Housatonic Valley Rail Trail Section II and III

Addendum #1

5/13/2024

BOLLARD

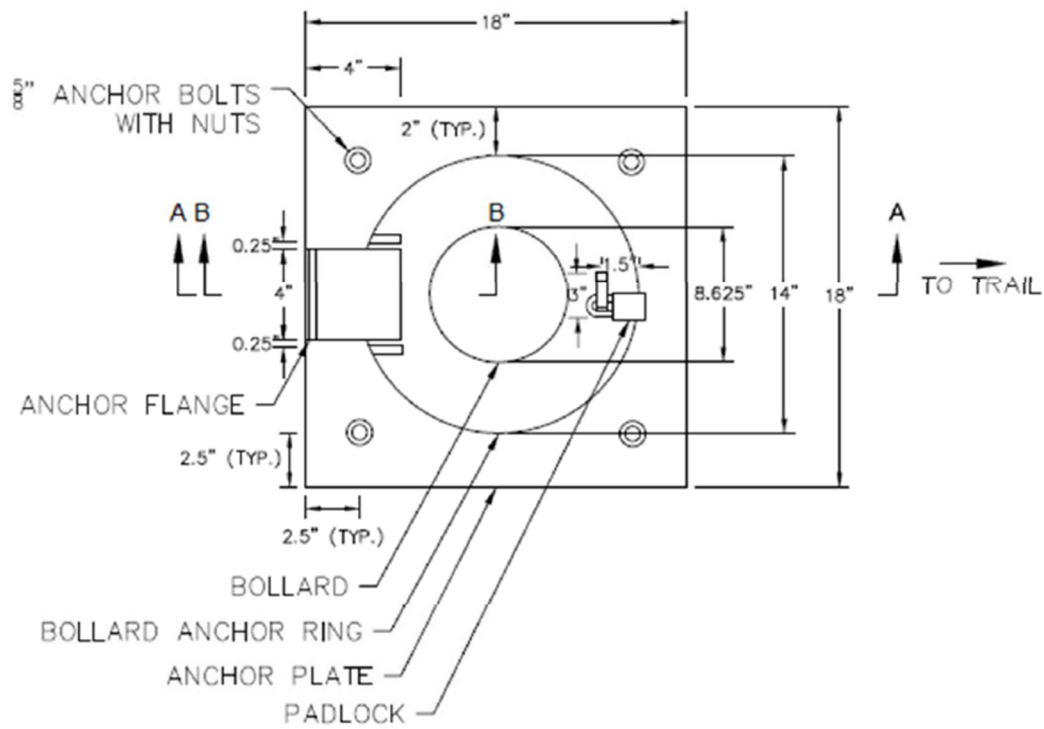
3. There was concerns over the specific bollard that was called out.
 - A. A revised specification has been attached to this addendum. It will be a similar style to what was utilized on other projects in town.

1. 8" DIA. (NOM.) STEEL PIPE BOLLARD. APPLY METAL PRIMER AND TWO FINISH COATS "TRAFFIC YELLOW" PAINT.
2. ATTACH BOLLARD ANCHOR RING TO BOLLARD WITH CONTINUOUS WELD.
3. 18"x $\frac{3}{8}$ "x1 $\frac{1}{2}$ " STEEL ANCHOR FOR PADLOCK TO EXTEND A MAXIMUM OF 1 $\frac{1}{4}$ " ABOVE BOLLARD ANCHOR RING. BORE HOLE TO EXCEPT PADLOCK SHANK.
4. WELD 1" HIGH UPRIGHT PLATES TO BOLLARD RING BOTH SIDES OF ANCHOR FLANGE. PLATES SHALL NOT EXTEND BEYOND OUTSIDE OF ANCHOR RING.
5. ANCHOR BOLTS SHALL NOT EXTEND MORE THAN $\frac{1}{4}$ " ABOVE NUT. TACK WELD NUT TO PLATE.
6. $\frac{3}{8}$ " GAP BETWEEN ANCHOR FLANGE AND ANCHOR RING IS CRITICAL TO ALLOW FOR BOLLARD REMOVAL.
7. ALL PLATES, FLANGES, AND ANCHOR RING SHALL BE $\frac{3}{8}$ " STEEL PLATE EXCEPT WHERE NOTED OTHERWISE.
8. BIT. CONC. PAVEMENT TO BE FLUSH WITH TOP OF ANCHOR PLATE.
